STATE BUILDING CODE TECHNICAL REVIEW BOARD

Friday, September 20, 2013 – 10:00 a.m.

In Re: Appeal of STNP, LLC
Appeal No. 12-1

In Re: Appeal of Keith Kurtz
Appeal No. 13-2

(BUILDING 1)

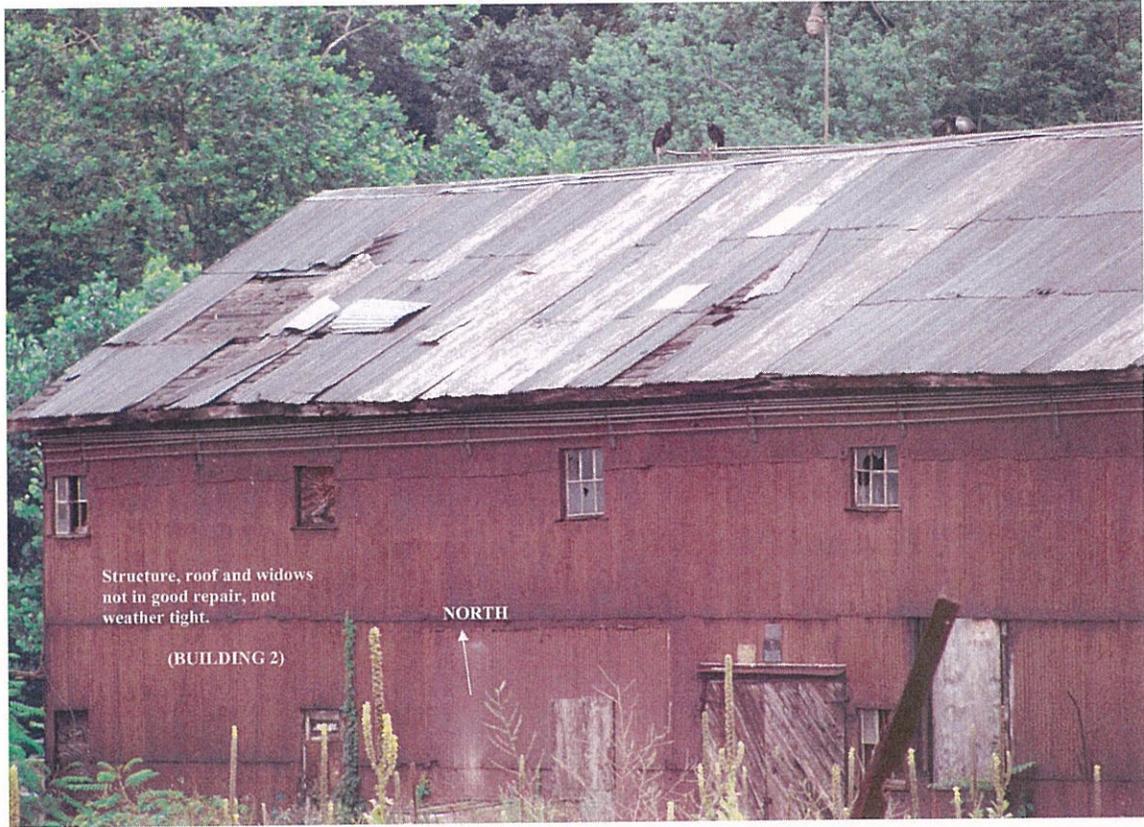
Structure open to elements and not weather tight

(BUILDING 2)

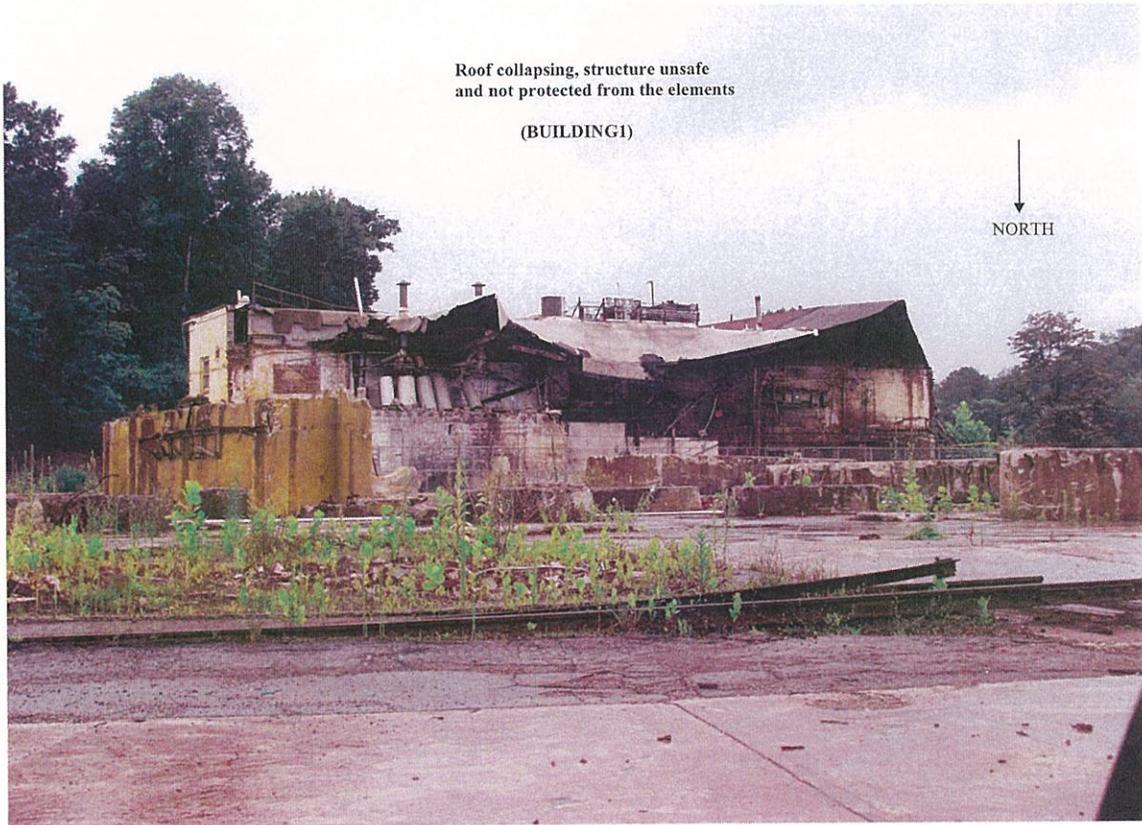
Structure, roof and widows
not in good repair, not
weather tight.

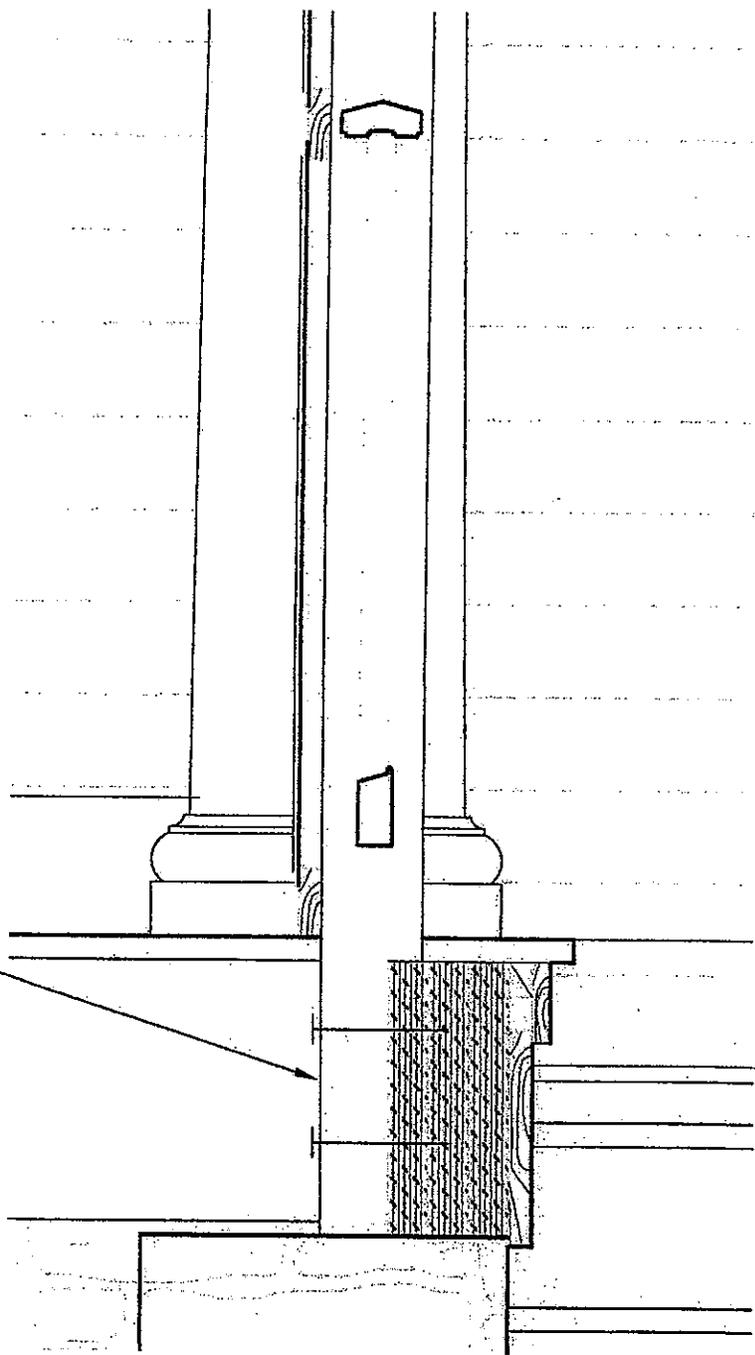
CAN THIS POST CONNECTION WITHSTAND 200 LBS OF LATERAL FORCH? *Yes.*

Provide (2) 1/2" φ lag screws, galvanized.

County Appeal Item VII B. Missing Hurricane Ties.

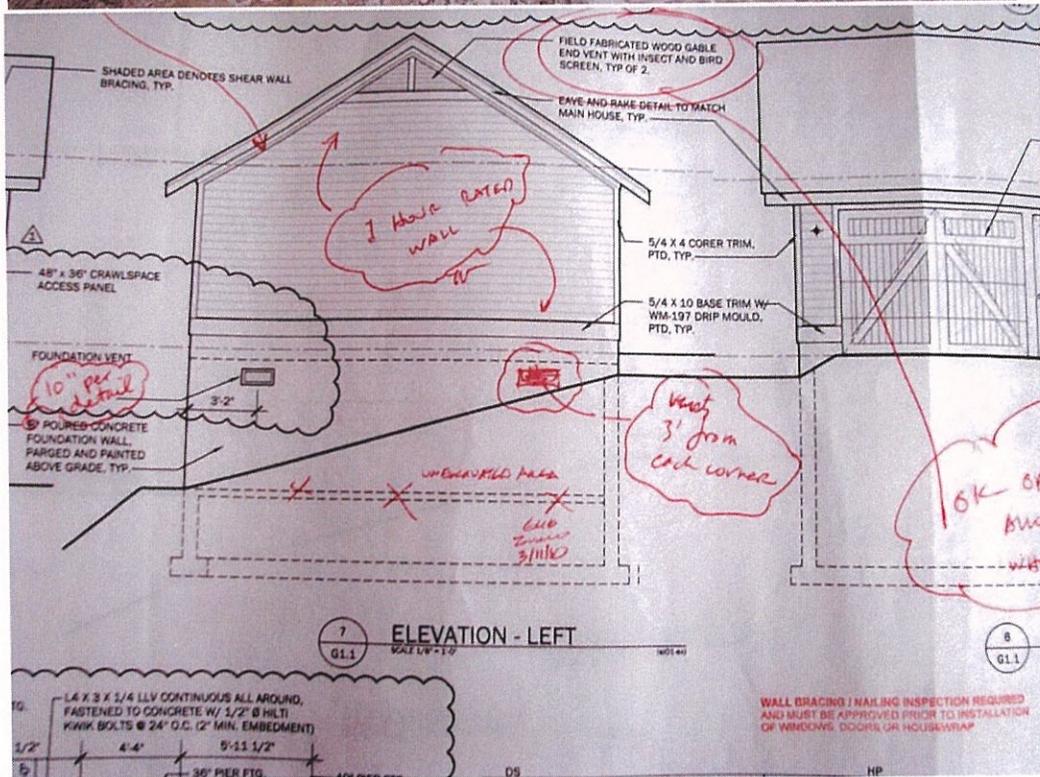
The garage drawings approved by Arlington County required Hurricane Ties (Simpson H-8).

The builder did not install them.

FIGURE 6

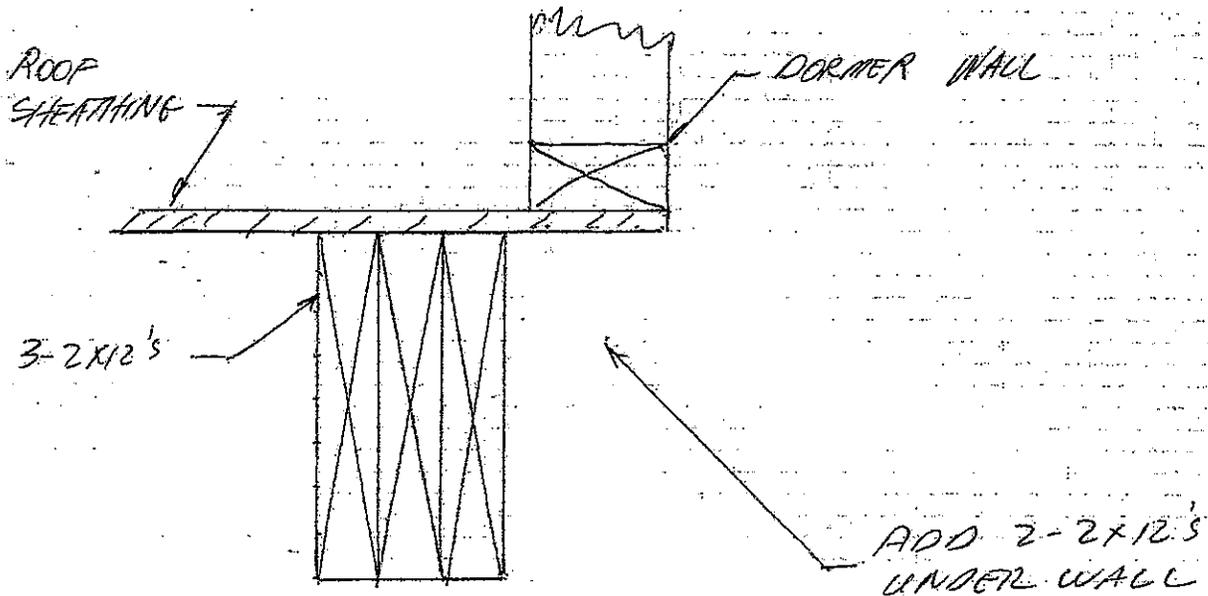
5. The dormer wall at the master bedroom (see CM 1.1 dated 3/25/11) was constructed off center (inboard) of the 3 - 2 X 12 rafters at the dormer (see Figure 6). This condition should be corrected by bolting 2 - 2 X 12's to the existing 3 - 2 X 12's and under the dormer wall for the entire wall length.

FIGURE 7

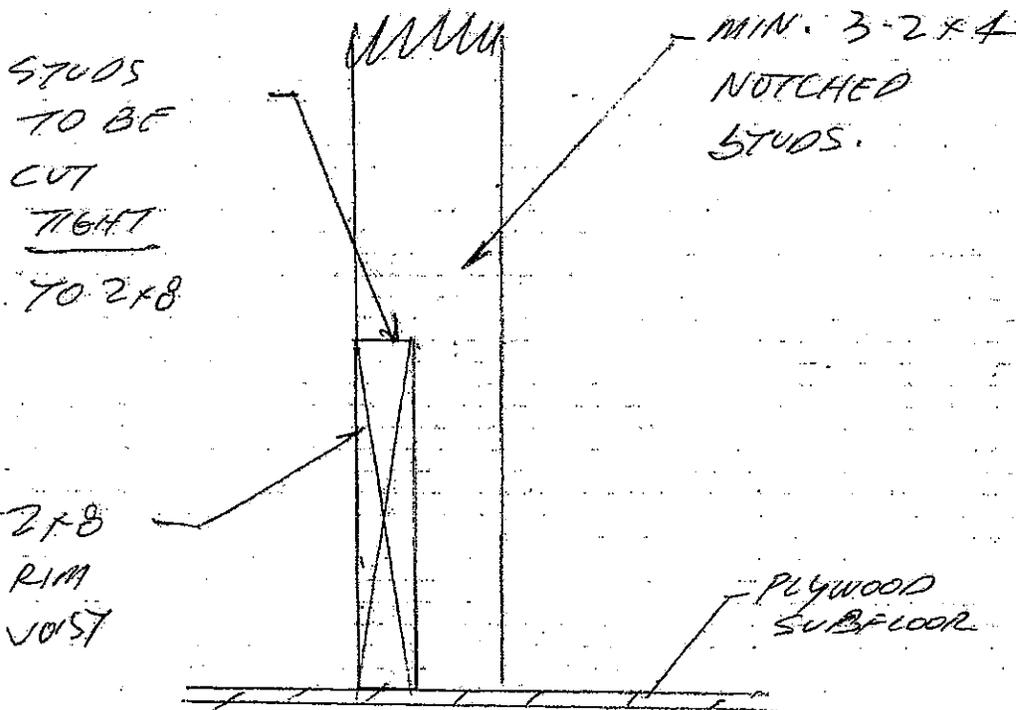
7. Post condition at first level study indicates a notched stud with inadequate bearing (see Figure 7). Also, it appears that this post does not track down to foundation below level 1. This condition needs to be corrected by installing 3 - 2 X 4 studs notched as indicated but having complete bearing on the let-in 2 X 8 joist. In addition, this post shall track down below level 1 to foundation.

Missing hanger location 1

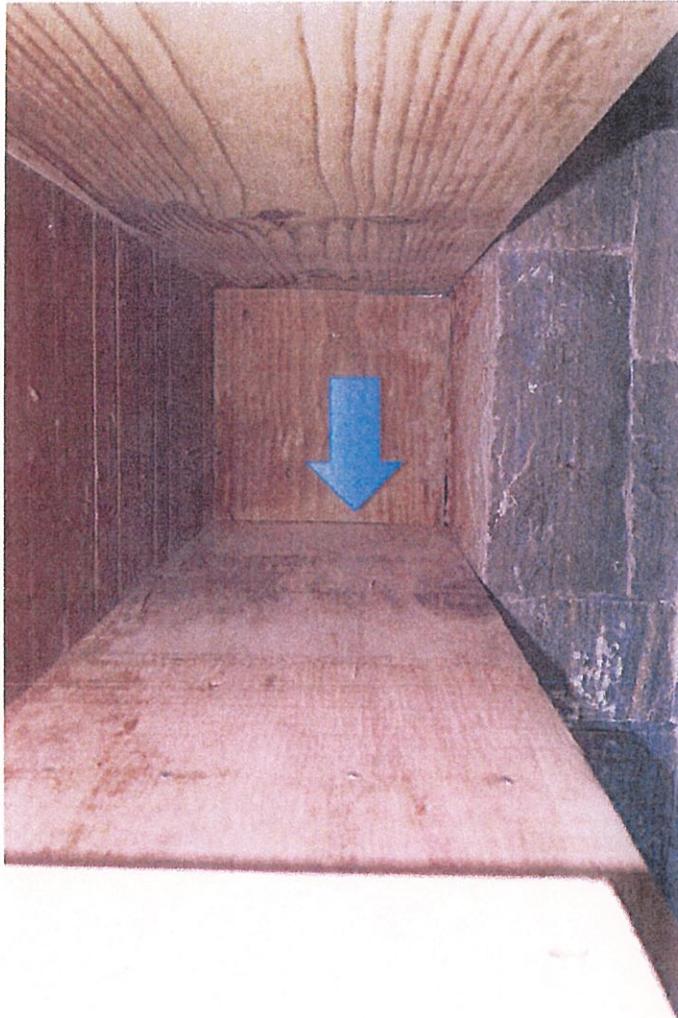
Similarly with Issue 1D, Arlington County Inspection Services Division is relying on a drawing (Moore Architects drawing 3.2) that shows specific hangers providing sufficient bearing. As seen in the attached photographs marked as Exhibit B, the specified hangers to attach the LVL are missing. The Simpson HUS 412 specified for location 1 (upper right of drawing) is not there, the HSUR/L410 specified for location 2 (upper left) is not there and the HUS 412 in location 3 (lower left) is not there.

Post supporting 4577 lbs.

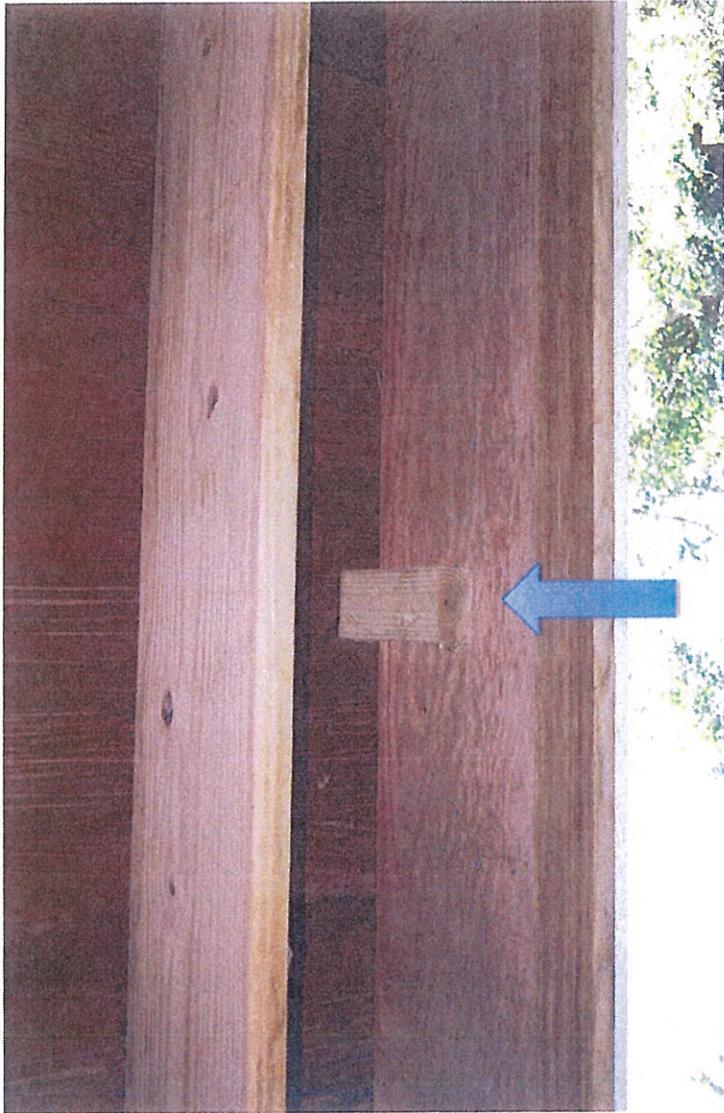
County Appeal item I. G. Sketch 3.2 shows a notched 4x4 post with 4577 lbs. load on the front LVLs. We questioned this previously. At our November 2011 meeting [with Arlington County Building Official, Mr. Amiri] one of the County staff said that this was not a problem because the post did not carry a significant load. Mr. Amiri asked that they verify that.

Missing 4x6 Post from MBR floor to Ridge Beam

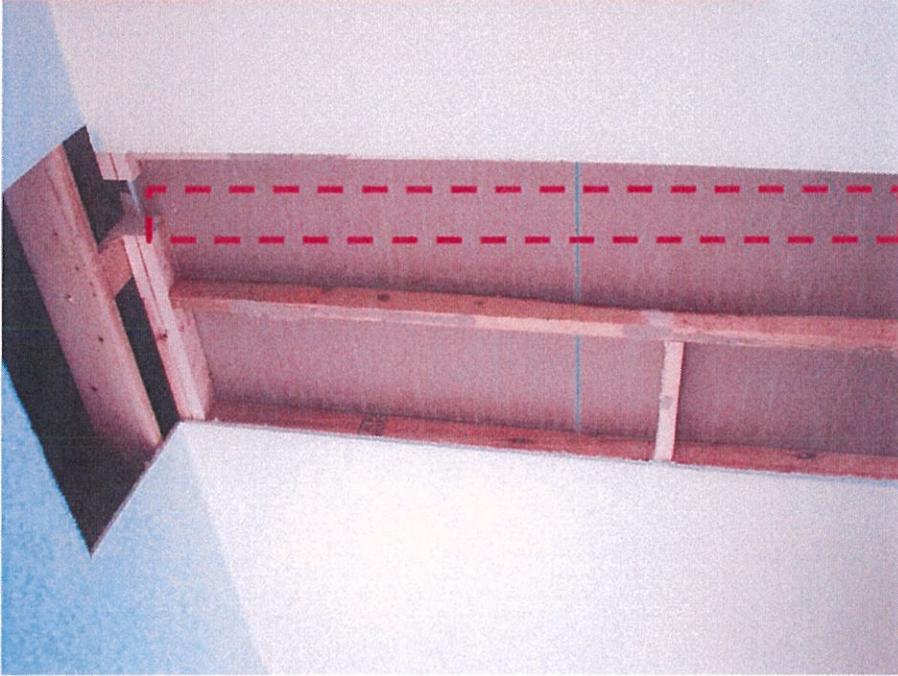
In September 2011 walls were opened up on three floors to prove the Moore was inaccurate.
